# HISTORIC AND DESIGN REVIEW COMMISSION

**HDRC CASE NO:** 2022-577  
**ADDRESS:** 305 LAVACA ST  
**LEGAL DESCRIPTION:** NCB 708 BLK 8 LOT 2 \*\*\*MASTER FILE-COMMON ELEMENTS\*\*\* (305 LAVACA TOWNHOUSES)  
**ZONING:** RM-4, H  
**CITY COUNCIL DIST.:** 1  
**DISTRICT:** Lavaca Historic District  
**APPLICANT:** Tim Rodgers/South Flores Construction  
**OWNER:** Tony Pearson/305 LAVACA TOWNHOUSES  
**TYPE OF WORK:** New construction of two 2-story single-family residences  
**APPLICATION RECEIVED:** May 23, 2023  
**60-DAY REVIEW:** July 22, 2023  
**CASE MANAGER:** Rachel Rettaliata

The applicant is requesting conceptual approval to construct two 2-story, single-family structures at 305 Lavaca.

SHEET#: A0.1  
PAGE 2 OF 7

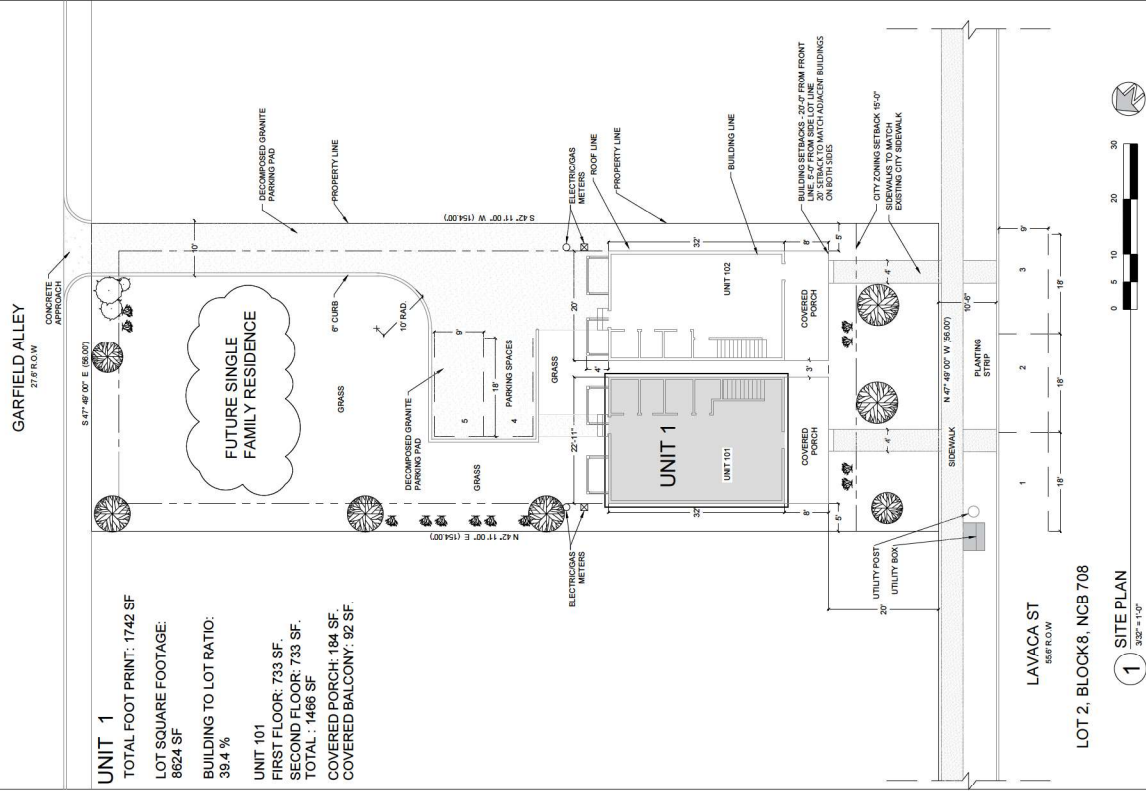
- e. **SETBACK & ORIENTATION (UNITS 1 & 2: LAVACA)** – According to the Guidelines for New Construction, the front facades of new buildings should align with the front facades of adjacent buildings where a consistent setback has been established along the street frontage. Additionally, the orientation of new construction should be consistent with the historic examples found on the block. The applicant has proposed to construct two 2-story, single-family residences at 305 Lavaca. The structures will be detached and will be oriented toward Lavaca Street. The applicant has noted that the proposed setback from the sidewalk will be 20 feet. The Historic Design Guidelines for New Construction stipulate that front facades should be aligned with the front facades of adjacent buildings. The applicant has shown that the neighboring setbacks are 20 feet. Staff finds that the applicant should provide a site plan setback diagram noting the setbacks of neighboring structures to show that the proposed new construction is aligned with or behind adjacent historic structures.

- i. That the applicant provides a site plan setback diagram showing that the proposed structures will not be located in front of the front façade wall planes of adjacent historic structures based on finding e.

① FRONT ELEVATION- SOUTH

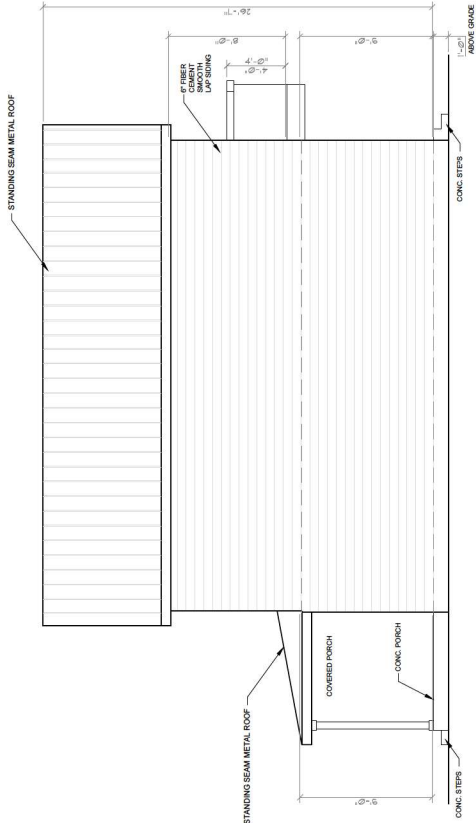
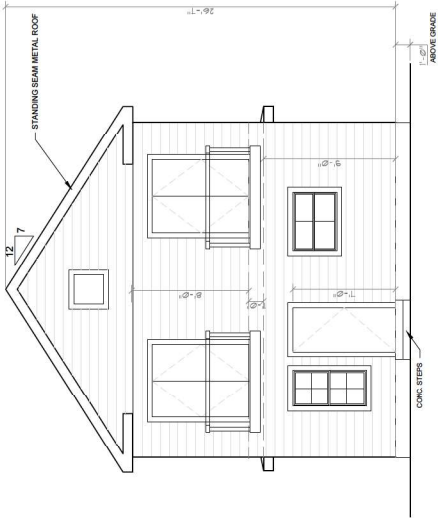
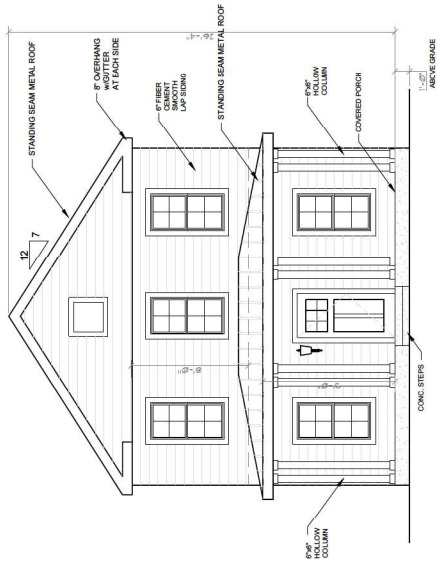
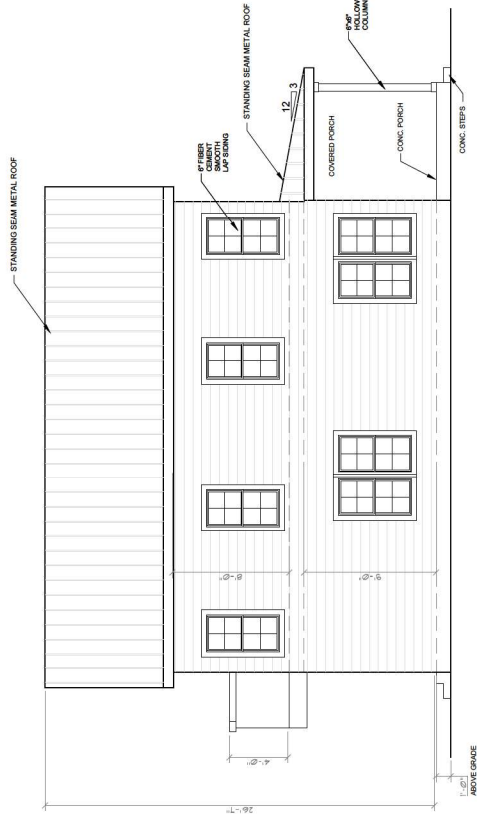
- g. **SCALE & MASSING (UNITS 1 & 2: LAVACA)** – According to Guideline 2.A.i for New Construction, new structures should feature a height and massing that is similar to historic structures in the vicinity. In residential districts, the height and scale of new construction should not exceed that of the majority of historic buildings by more than one story. Guideline 8.A.ii for Medium-Density and Multifamily states that multiple dwelling units should be incorporated into historically-common building sizes and forms within the established context area. For example, in context areas having larger buildings, four units may be appropriately combined into a single, two-story building form. In context areas with smaller buildings, a more appropriate response would be to separate the units into smaller, individual building forms. This block of Lavaca features 1-story and 2-story historic structures. Guideline 2.A.ii for New Construction states that applicants should utilize step-downs in building height, wall-plane offsets, and other variations in building massing to provide a visual transition when the height of new construction exceeds that of adjacent historic buildings by more than one-half story. Guideline 8.D.iii for Medium-Density and Multifamily states that applicants should separate building massing into distinguishable architectural bays consistent with historic buildings within the established context area. This is best accomplished through a change in wall plane or materials, or by aligning appropriately-scaled fenestrations. The applicant has proposed to construct two 2-story, single-family structures facing Lavaca. The existing historic structure located to the east of the lot along Lavaca is a 1-story residence. The applicant has provided a total ridge height of 26'-7" for Unit 1 and a total ridge height of 23'-5" for Unit 2. Unit 2, sited next to the neighboring 1-story historic structure, features a second story projection that extends the ridge height of 21'-9" forward interrupting the lower-scale front porch volume. The neighboring 1-story structure features a

ridge height of 22 feet but features a front façade projection that is lower than the total ridge height. Staff finds that the massing of Unit 2 should be reduced to provide a visual transition consistent with the Guidelines.

- i. ROOF FORM (UNIT 1: LAVACA) – The applicant has proposed front gable roof form for Unit 1. According to Guideline 2.B.i for New Construction, new construction should feature roof forms that are consistent with those predominantly found on the block. This block of Lavaca features structures with front gable roofs, cross gable roofs, side gable roofs, hip roofs, and shed roofs. Staff finds the proposal consistent with the Guidelines.

- m. RELATIONSHIP OF SOLIDS TO VOIDS (UNIT 1: LAVACA) – The applicant has proposed to install one-over-one windows on Unit 1. Guideline 2.C.i for New Construction states that window and door openings should be incorporated into new construction with a similar proportion of wall to window space as typical with nearby historic facades. Windows, doors, porches, entryways, dormers, bays, and pediments shall be considered similar if they are no larger than 25% in size and vary no more than 10% in height-to-width ratio from adjacent historic facades. The elevation drawings are incorrectly labeled; however, the west elevation currently features limited fenestration, and the east elevation features no fenestration. The proposed front façade features windows that appear larger than traditional windows found on historic structures in the vicinity and the rear elevation features a horizontally-oriented window that is not a traditional configuration. Staff finds that the proposed fenestration should be updated to be more in keeping with the Guidelines.

- ii. That the massing of Unit 2 is reduced to provide a visual transition to the neighboring historic structure that consistent with the Guidelines based on finding g. The applicant must submit updated drawings to staff for review.

- iv. That the applicant proposes window sizes, patterns, proportions, and trim and sill detailing that are consistent with the Guidelines and historic precedents in the district as noted in findings m and n.
